Purlin Spacing and Brace Request

Notice to our pre-engineered metal building manufacturer:

Several Brace Clip Options

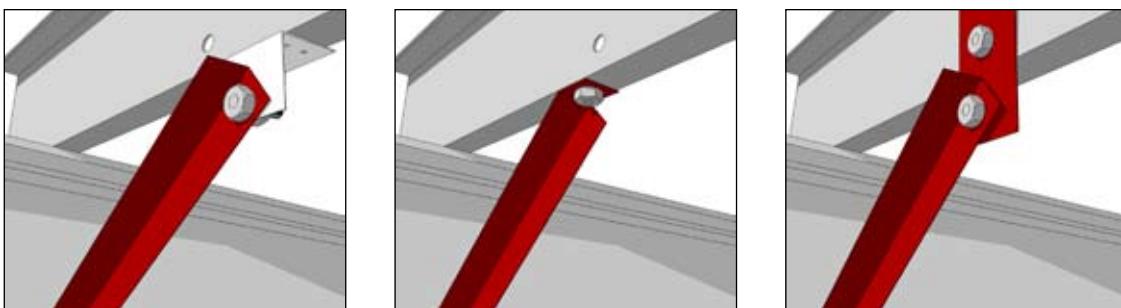
Rafter brace attachments to the purlins can also be time consuming to work with. Bolting braces to the side of the purlins must penetrate the ceiling liner and are difficult to seal. Most manufacturers provide one of the following options. Please adopt and approve for use one of the following details for use with this project.
